## RB271-06/07

### R807.1

## RB272-06/07

### R807.1

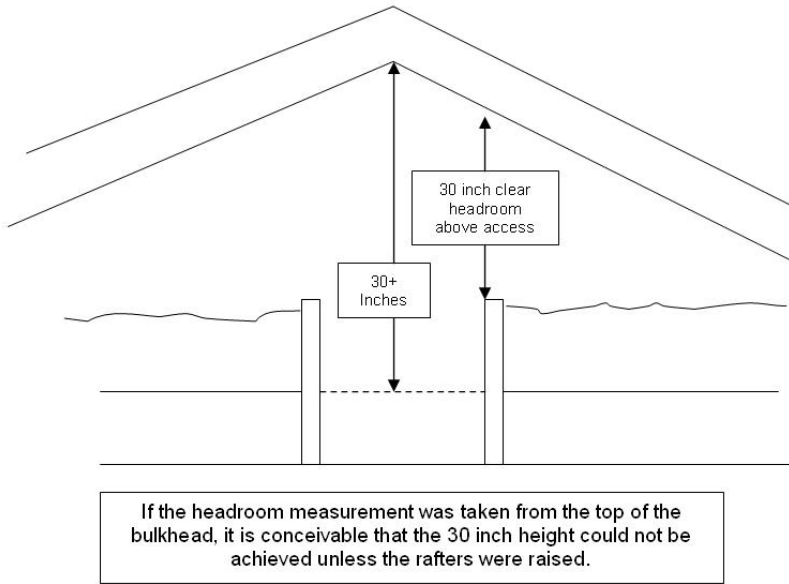
**R807.1 Attic access.** Buildings with combustible ceiling or roof construction shall have an attic access opening to attic areas that exceed 30 square feet (2.8m<sup>2</sup>) and have a vertical height of 30 inches (762 mm) or greater. The vertical height shall be measured from the top of the ceiling framing members to the underside of the roof framing members.

The rough-framed opening shall not be less than 22 inches by 30 inches (559 mm by 762 mm) and shall be located in a hallway or other readily accessible location. When located in a wall, the opening shall be 22 inches wide by 30 inches high. When located in a ceiling, a A 30-inch (762 mm) minimum unobstructed headroom in the attic space shall be provided at some point above the access measured vertically from the bottom of ceiling framing members. See Section M1305.1.3 for access requirements where mechanical equipment is located in attics.

**Reason:** The code is not clear on how the vertical height should be measured. If you want uniformity and enforceability, the code must stipulate the method. Should it be measured from the bottom of the ceiling joist, the top of the ceiling joist, or the top of the insulation? Should it be measured to the underside of the roof sheathing or the underside of roof framing members? It needs to be verified during the framing inspection so that excludes measurements involving insulation. Since the depth of framing members can approach or exceed one foot, it would seem that a reasonable approach would be to measure from the top of the ceiling members to the underside of the roof members to determine the vertical height. That suggestion is proposed. If you measure from the bottom of the ceiling members to the top of the roof members, you may only have a foot or so of working height.

The second modification acknowledges that some attic accesses are through a knee wall and provides direction on the installation of the opening for those situations.

The third modification stipulates that the 30-inch clear headroom above the access be measured from the underside of the ceiling framing members or the lowest point of the attic access. It is common practice where attics are insulated to construct a bulkhead in the access to contain attic insulation. If one were to measure the headroom requirement from the top of the bulkhead, you could conceivably have a situation where you would have to require that the roof framing be raised to achieve 30 inches of headroom. That is unreasonable.

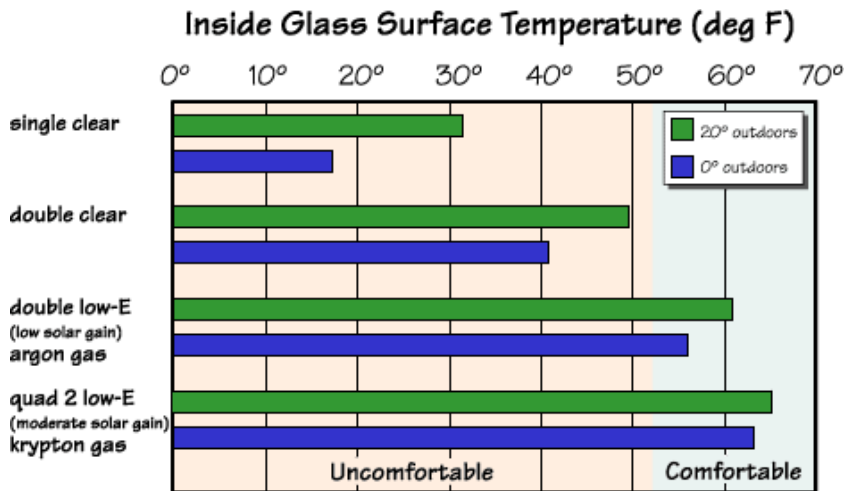
The following chart produced by the Lawrence Berkley National Laboratory (and found on the Efficient Window Collaborative website – [www.efficientwindows.org](http://www.efficientwindows.org)) shows the condensation potential for different types of configurations at various outdoor temperature and indoor relative humidity conditions.

This graph indicates that condensation will occur at any point on or above the curves. For example, at 0°F a double-glazed clear window represented by the gold line (approximately 0.55 U-factor) will have condensation present at 40% relative humidity. For a double-pane low-E window (0.48 in an aluminum frame, 0.40 U-factor or better in a vinyl or wood frame) – represented by the green line – the relative humidity could be as high as 60% before condensation would occur. This graph clearly shows that as the U-factor of windows improves, there is a much smaller range of conditions where condensation will occur, and establishes the need for this level of U-factor limits.

Pacific A 3

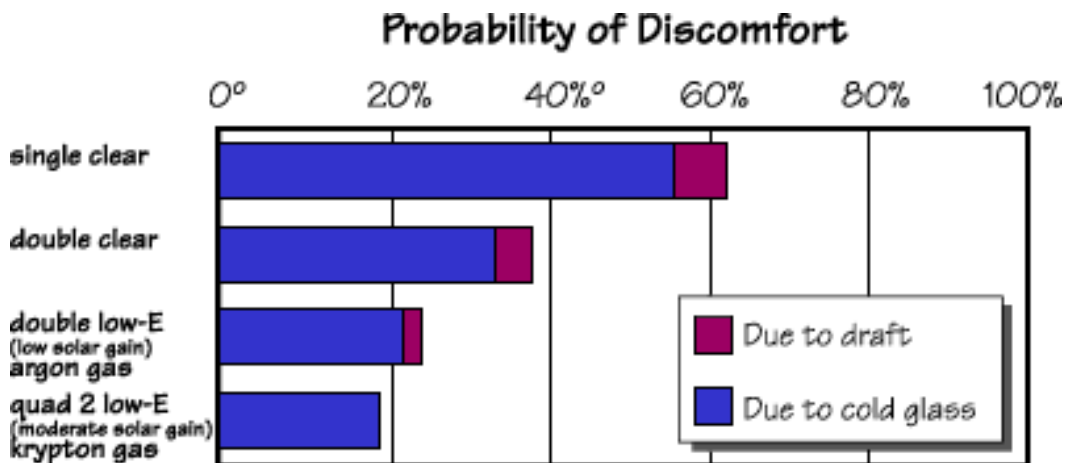
The following two charts produced by the Lawrence Berkley National Laboratory (and found on the Efficient Window Collaborative website – [www.efficientwindows.org](http://www.efficientwindows.org)) illustrate the comfort issues with using the wrong windows (higher U-factors) in colder climates. Specifically, the first chart shows the temperature of the inside glass surface on various windows. The 0.55 U-factor requirement in the IRC would be comparable to double clear glass. The 0.40 U-factor requirement in the IECC for zones 6-8 would be comparable to double low-e.

Similarly, the second graph shows the probability of winter discomfort from the same types of glass.

It is clear from these two charts that reasonable comfort requires low-e windows in heating climates, particularly with unlimited window area now allowed. It should be noted that even at a 0.40 U-factor, such a window allows far more heat loss than an un-insulated frame wall. For all of these reasons, the IRC provision should be revised to be consistent with the IECC provision.
